Docket Nos.: 50-443
and 50-444

Subject: Seabrook Probabilistic Safety Assessment (PSA) Review

A REVIEW OF THE SEABROOK STATION PROBABILISTIC
SAFETY ASSESSMENT: CONTAINMENT FAILURE
MODES AND RADIOLOGICAL SOURCE TERMS

September 1985

Figure 3.8 A pictorial representation of leakage categories.

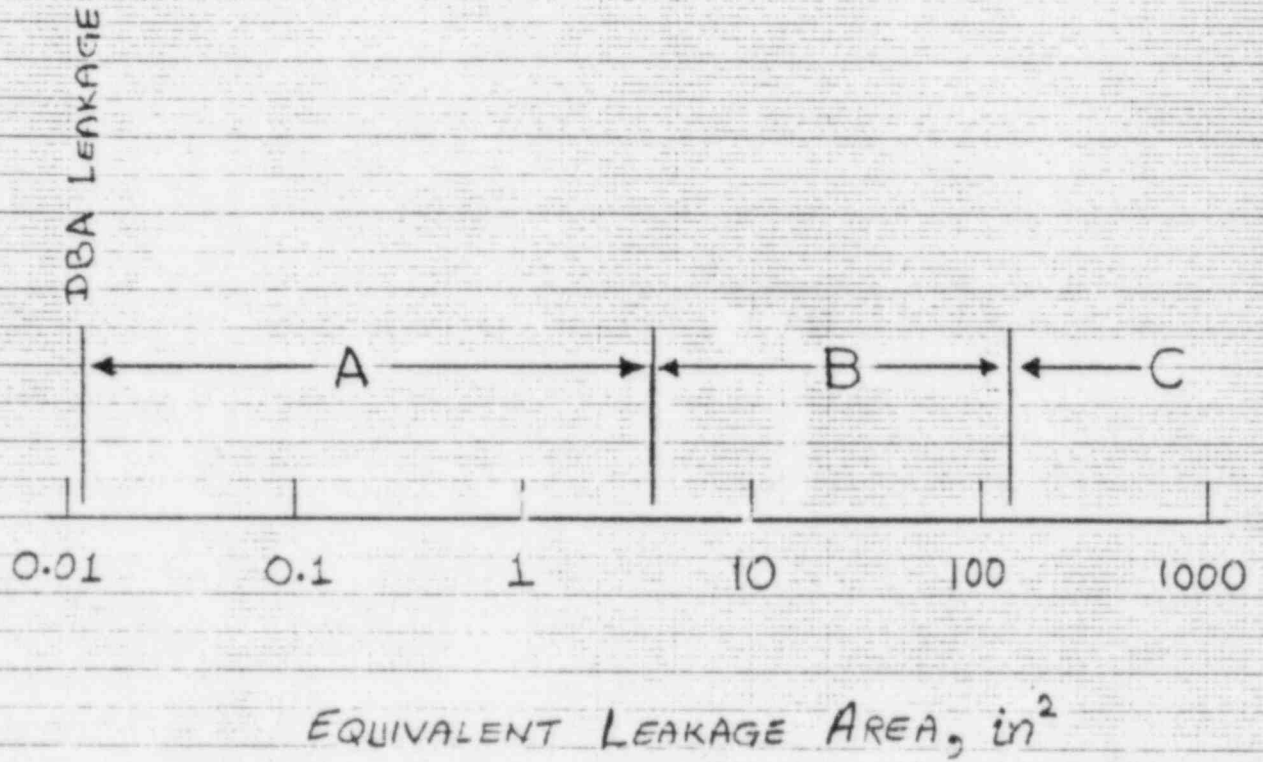
The leakage area required to arrest containment pressurization is in the
range of 4 to 10 square inches, the lower value being more representative of
wet sequences and the upper value is representative of dry sequences. A leak
area of about 6 square inches will result in the release of about 100 w/o of
activity in a day (see Eq. 7). The upper bound leak area for Type A failure
is taken as 4 in^2 . This corresponds to release of the radioactive source term
(100% turnover) in about 36 hours. The Category B leak area is, thus, in the
range of 4 in^2 to 1 ft^2 . Figure 3.8 is a pictorial representation of these
leakage categories.

Figure 3.9 Estimated radial displacement of containment wall.

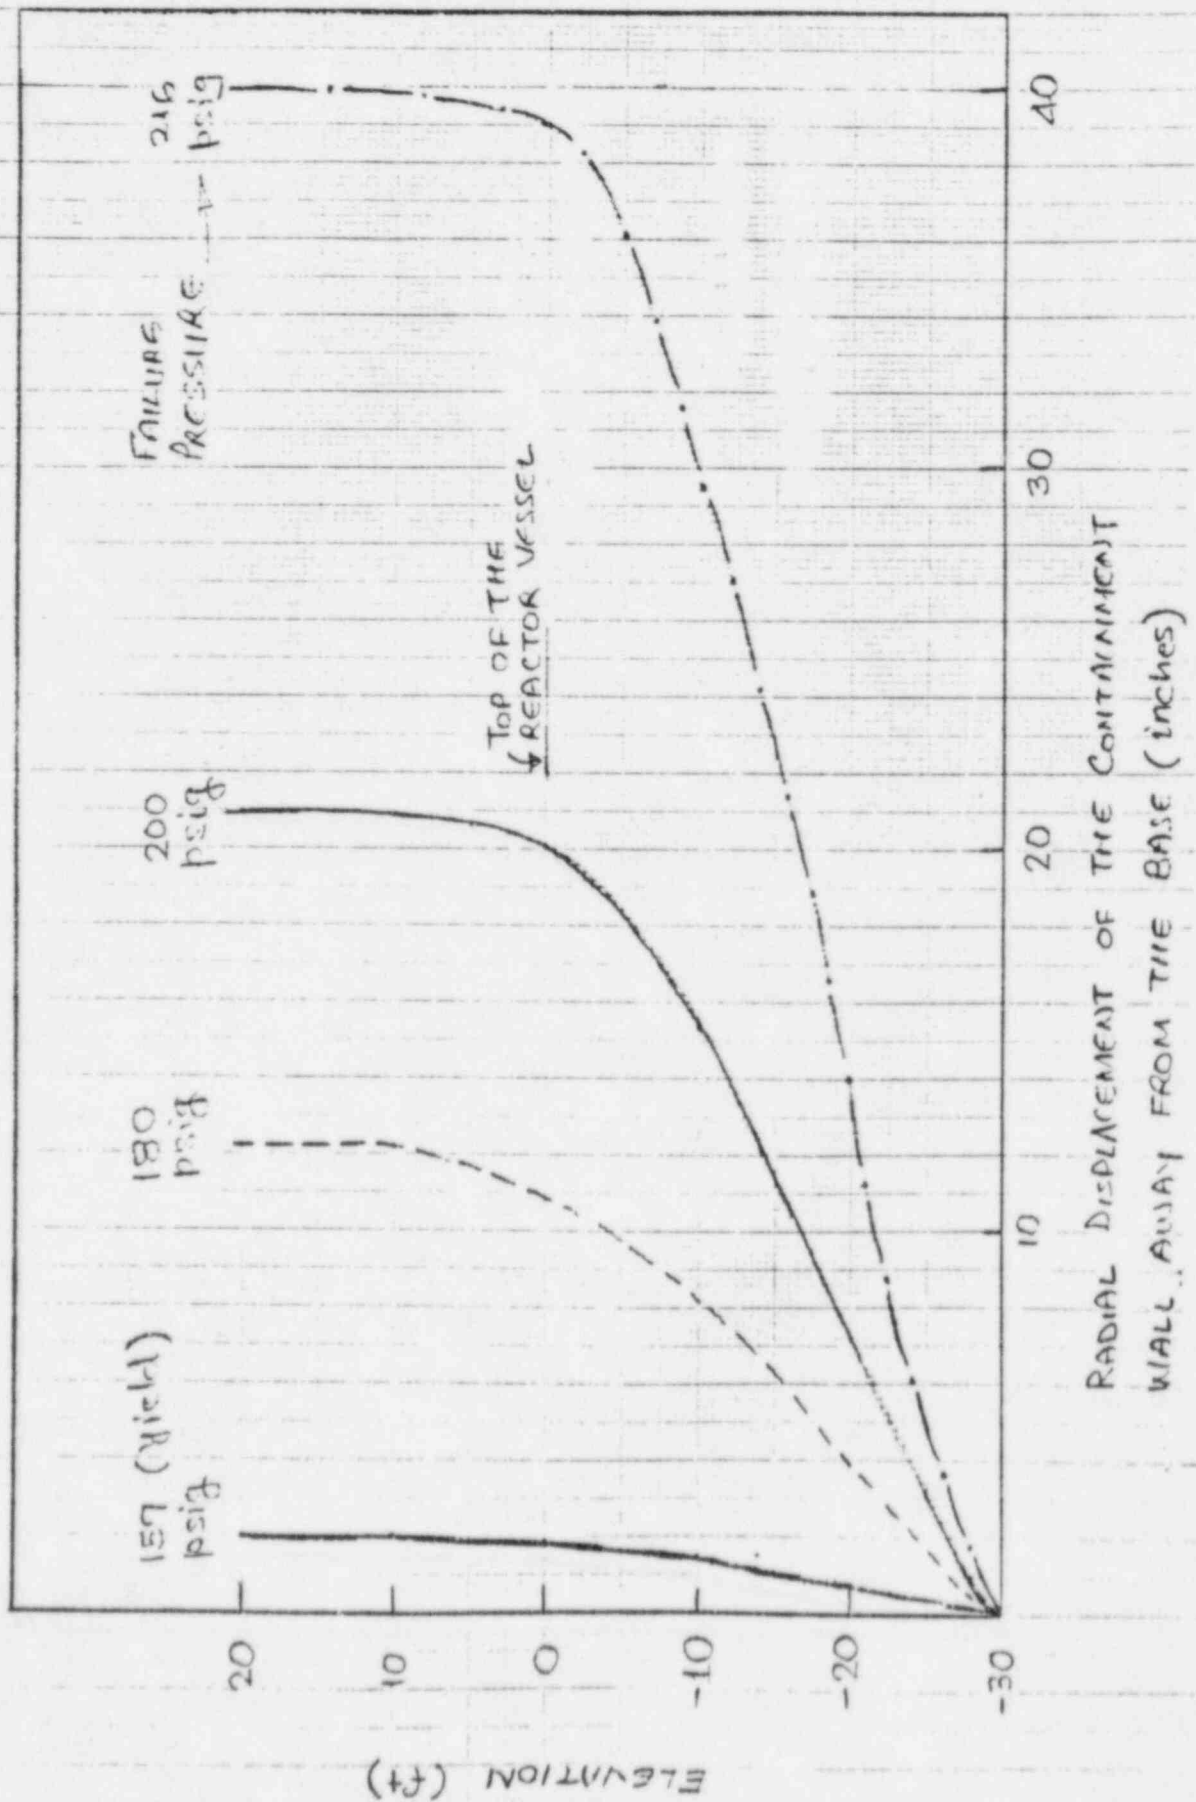
compiled radial deformations of the containment wall are shown in Figure 3.9.
Note that the radial strain at the expected failure pressure of 216 psi is

The hemispherical dome was calculated to yield at a slightly higher pres-
sure (163 psig). The failure pressure is predicted at 223 psig.
